**KOLKATA METRO RAIL CORPORATION LIMITED
(A Government of India Undertaking)**

ADDENDUM NO.-3

NIT No. : Civil/1 of 2015-16 of Managing Director, KMRCL

Contract No. EWSAFEM: Architectural Finishing, Plumbing, Tubewell, VAC, Electrical, Fire Fighting Works for 6 Elevated Stations including lighting of Viaduct & lighting of TSS/ASS of Car Depot and RCC Structural roof over Platform of Sector-V Station of East West Corridor of Kolkata Metro

TENDER DRAWING			
		KOLKATA METRO RAIL CORPORATION LTD (KMRCL)	
General Consultants

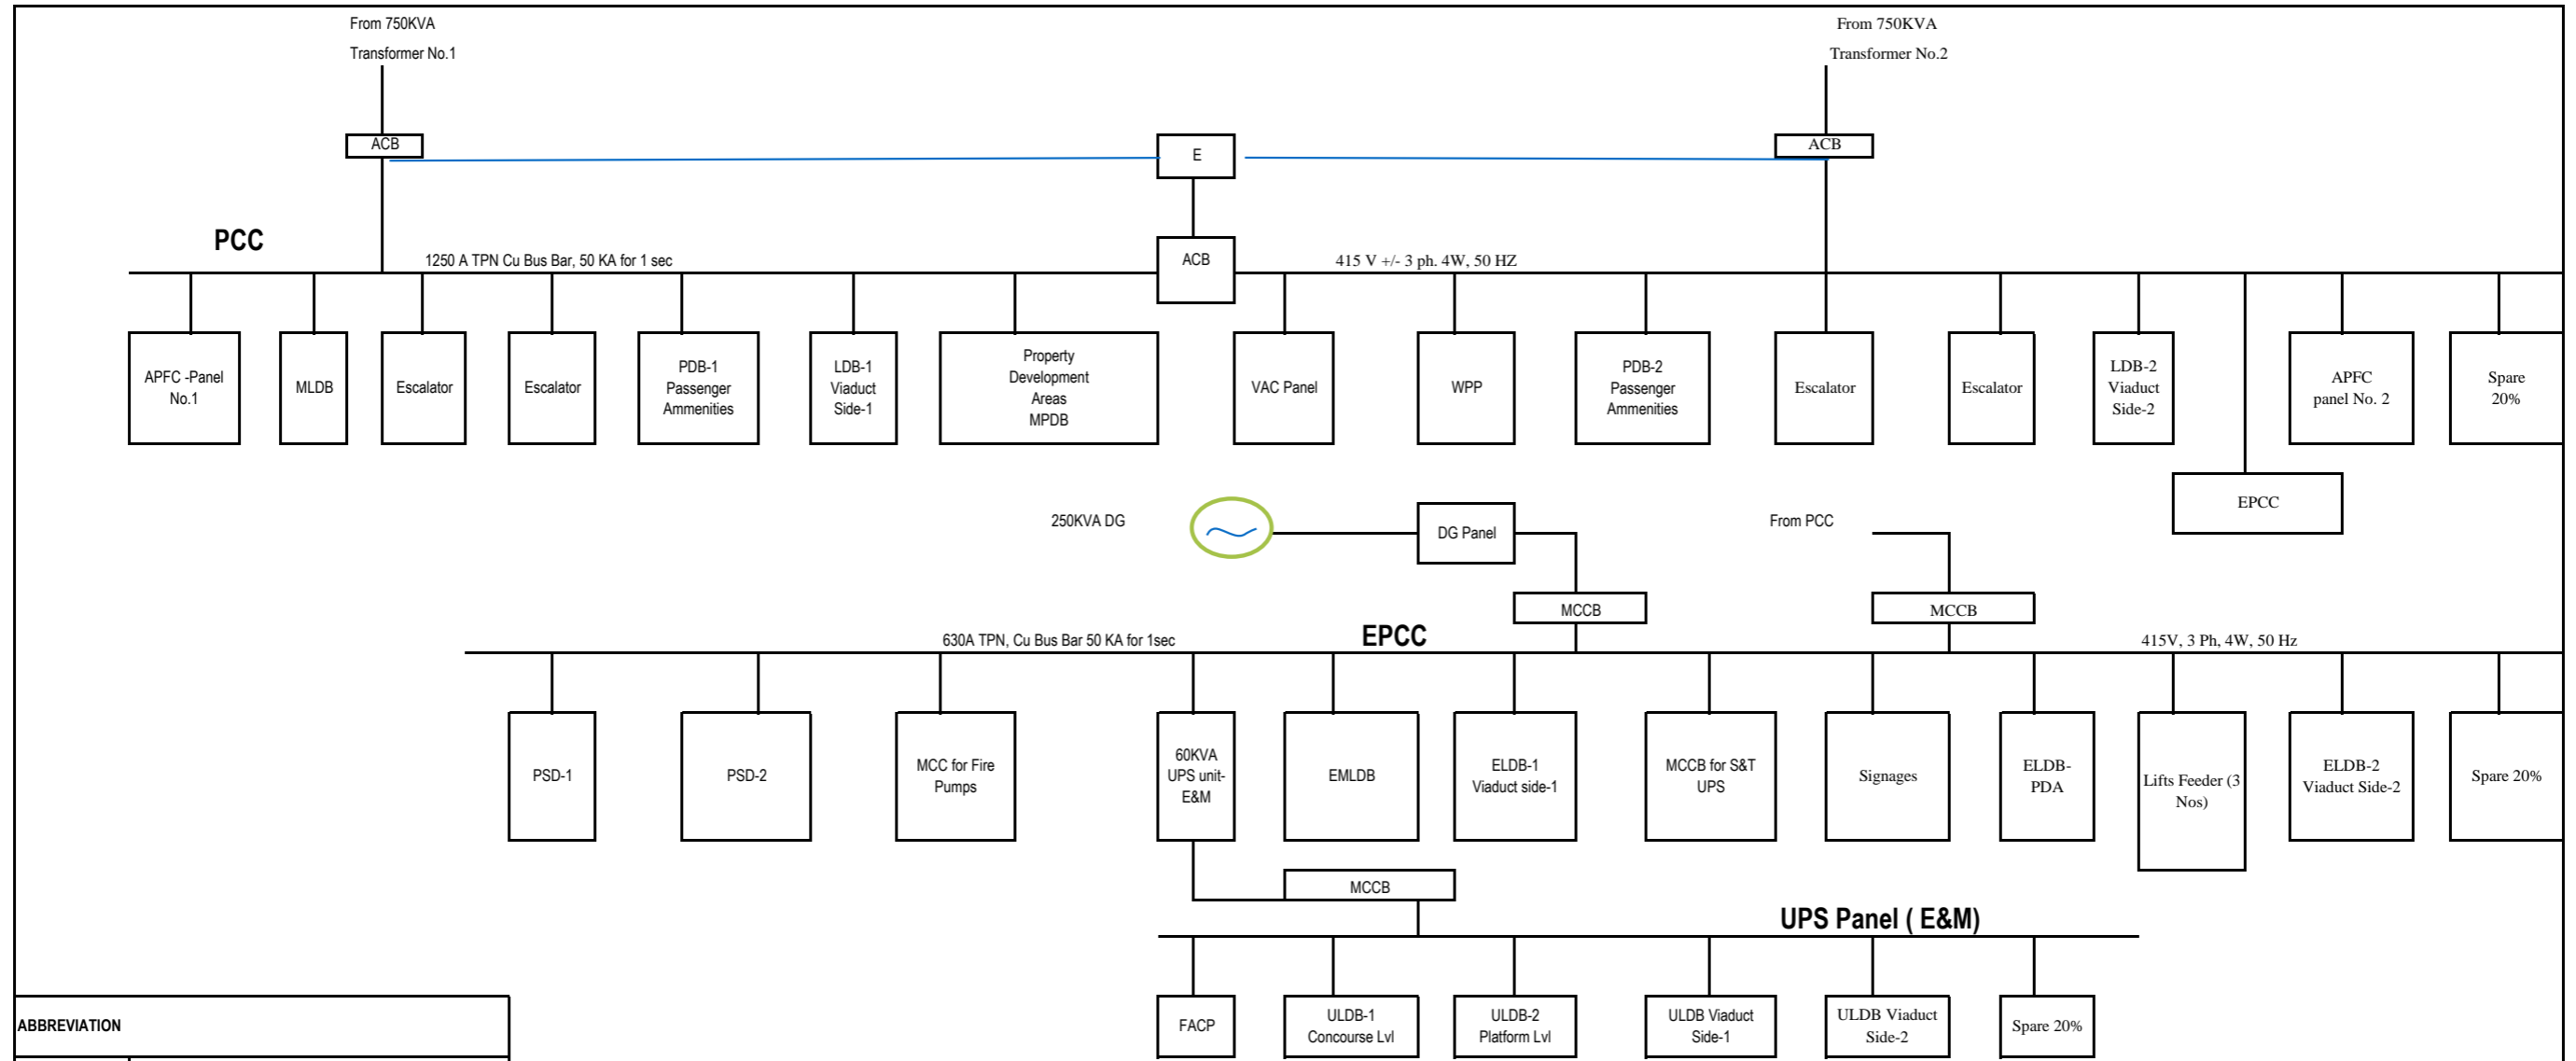
92	5	--	--	Power Distribution Block Riser Diagram (Typical) – Elevated Station Drg. No. KMRCL/E&M./ELEV./001 (Rev R0)	Power Distribution Block Riser Diagram (Typical) – Elevated Station Drg. No. KMRCL/E&M./ELEV./001 (R1)
93	3 (Part-I)	Clause 5.2	45 of 117	Concrete Facing Blockwork for General Use a. Blocks: To IS 2185 (Part-1) 1979. b. Type: Solid c. Minimum average compressive strength: 7.5 N/mm ² d. Maximum thermal conductivity at N/A % moisture content	Concrete Facing Blockwork for General Use a. Blocks: To IS 2185 (Part-3) - 1984 b. Type: Autoclaved Cellular (Aerated) c. Minimum compressive strength: 7.0 N/mm ²

- 1 THIS DRAWING IS TENDER PURPOSE ONLY.
- 2 THIS GIVES A TENTATIVE OVERALL OUTLINE OF POWER DISTRIBUTION OF PROPOSED WORK FOR ELEVATED STATION
- 3 POWER SUPPLY (415V) ARRANGEMENT (MPDB) FOR PROPERTY DEVELOPMENT AREA (PDA)- ONLY IN BENGAL CHEMICAL & SALT LAKE SECTOR- V STATION
- 4 THE UNINTERRUPTED POWER SUPPLY FOR AFC SHALL BE FED FROM S&T'S UPS PANEL
- 5 AUTO TRANSFER SOURCE SYSTEM WITH NECESSARY INTERLOCKING BETWEEN INCOMER 1 & 2 OF EPCC
